Architect's Supplemental Instructions

Architect's ASI No: 009

Project:
Webster University
Interdisciplinary Science
Building

Date Issued: 08/01/2016

A0102.B

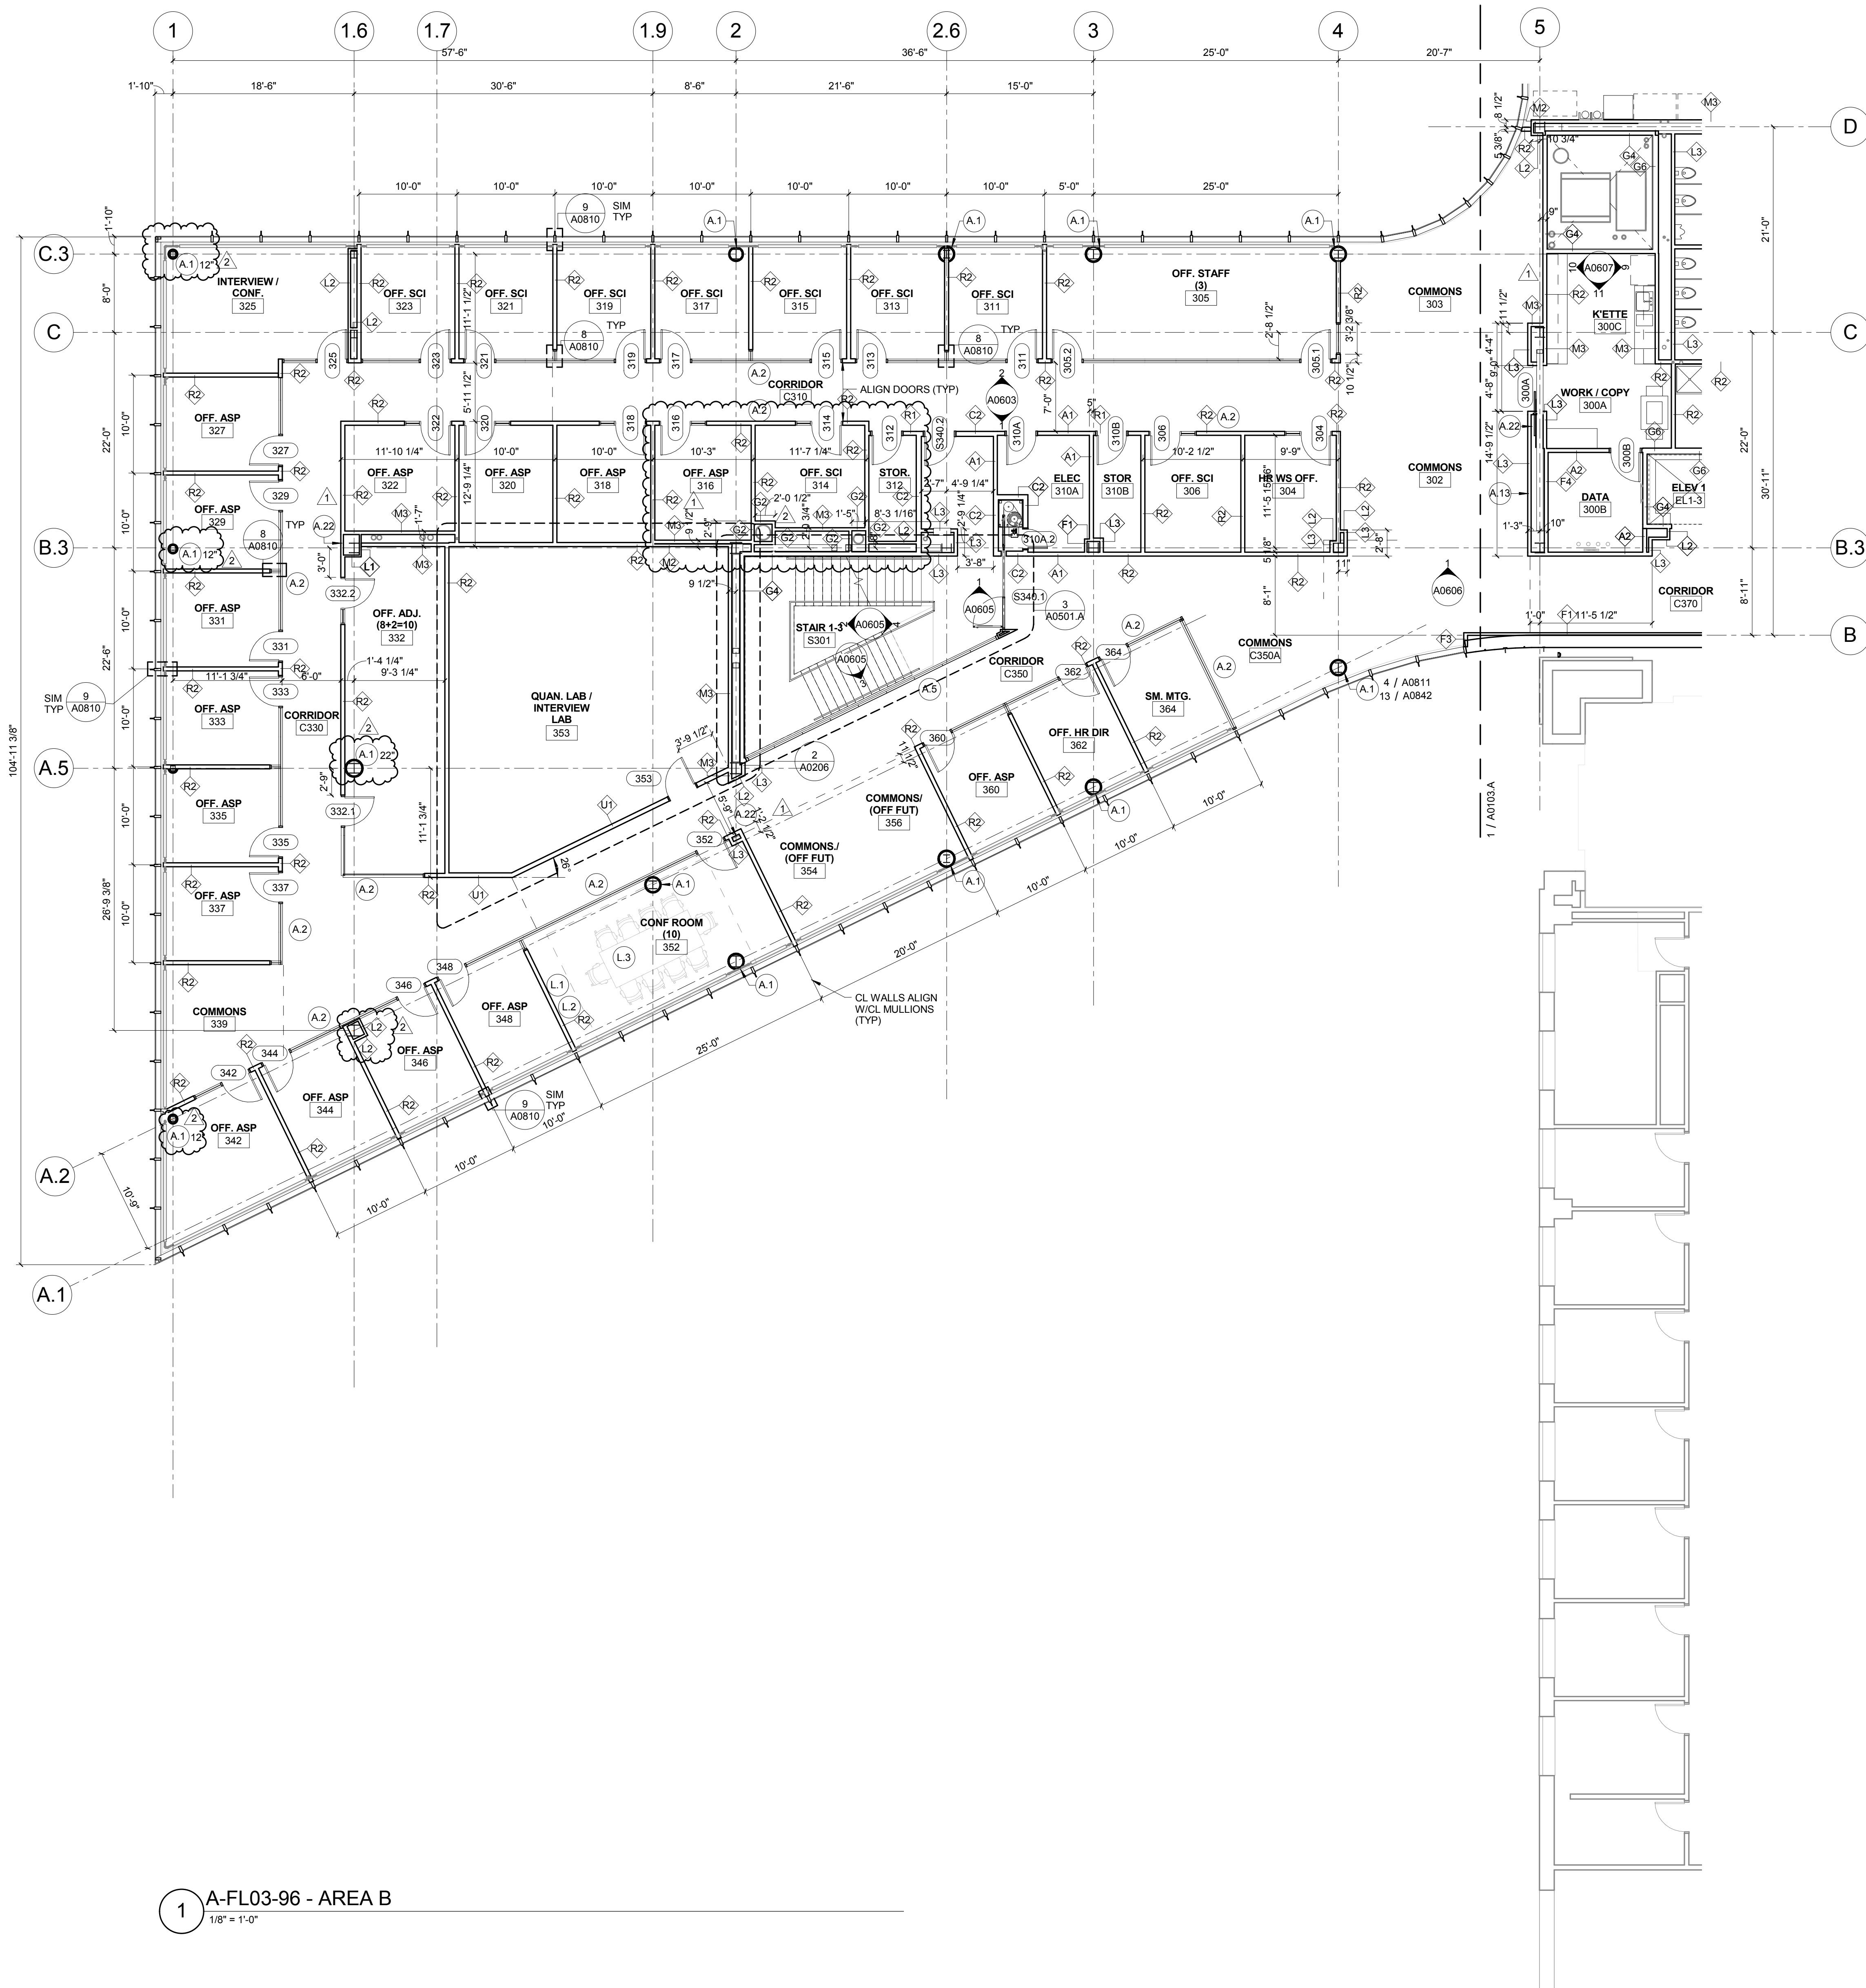
1. Architectural Drawings: Modifications to partition layout to accommodate and enclose exhaust duct near B.3 between 2 and 2.6. (RFI 192-response) and Piping south of column line B on level 04 (RFI 176 response) and to modify chase and office layout at exhaust duct at B.3 and 2 to better accommodate offices 314 and 316.

A0103.B

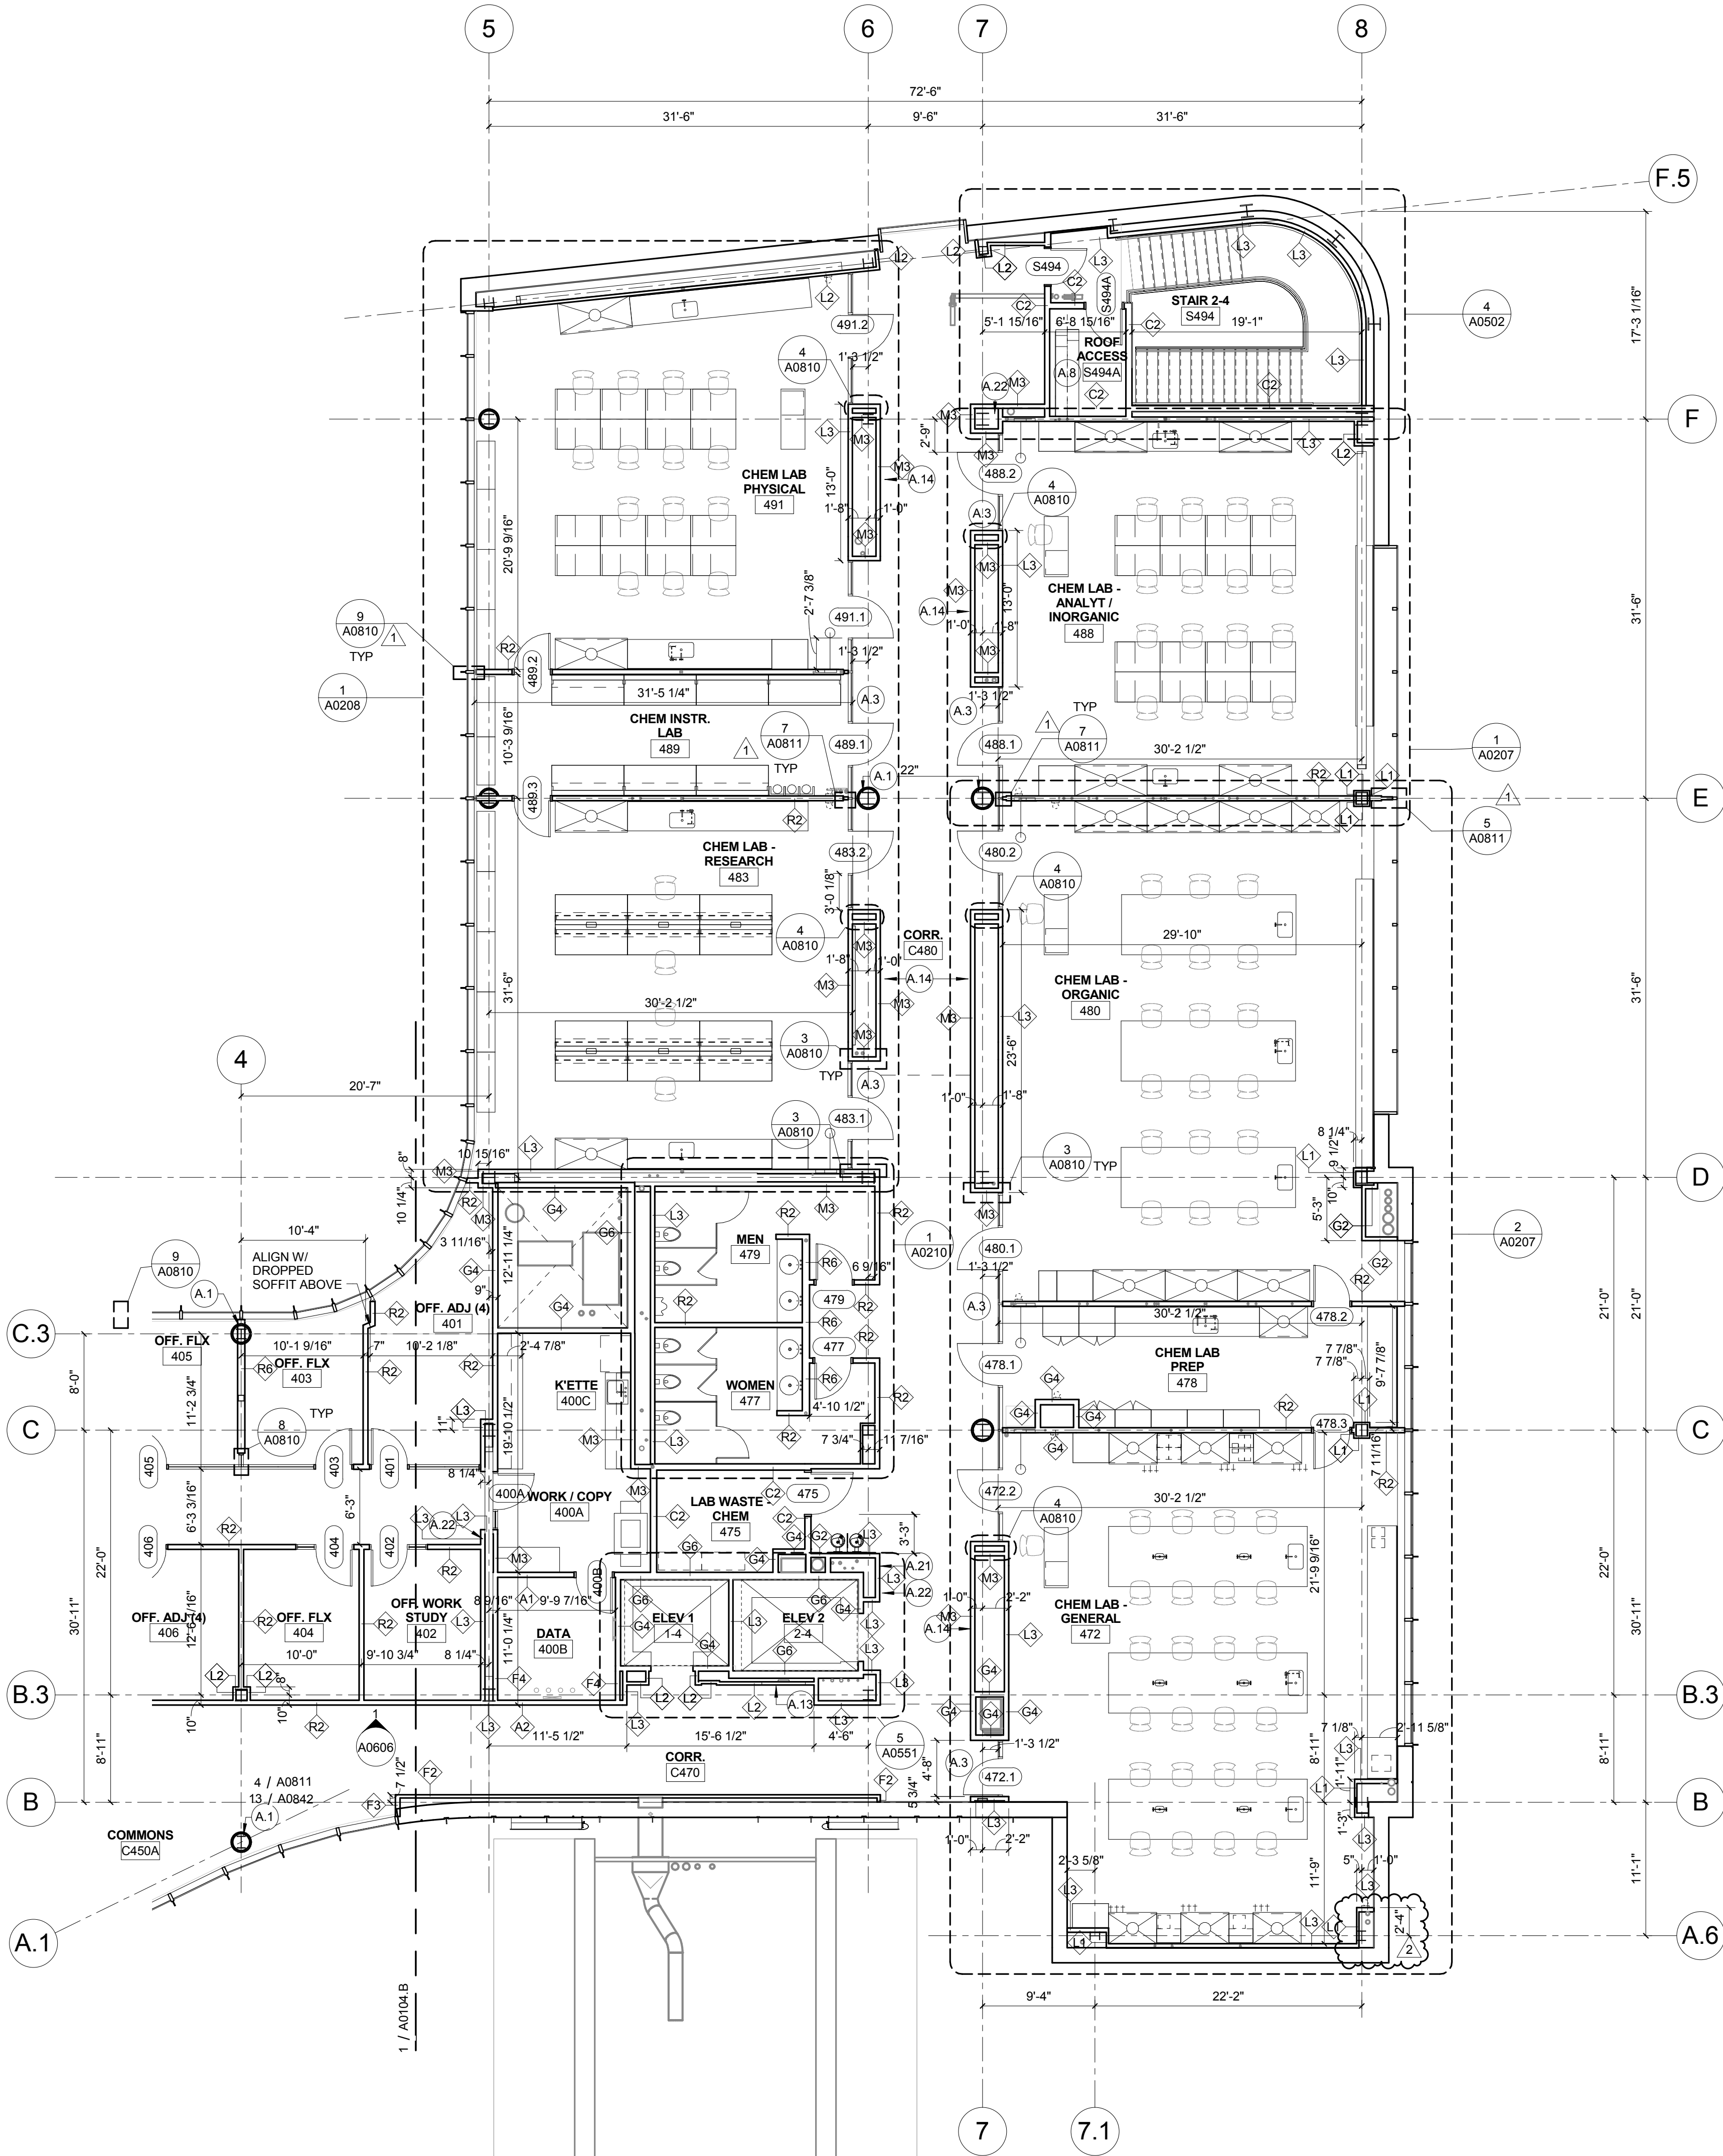
2. A0103.B: Clarification of column covers
3. A0104.B and A0704.B: Cleanup and Clarification of partitions @ column line 2.6 at north and south exterior walls. Modified room name of room 431.
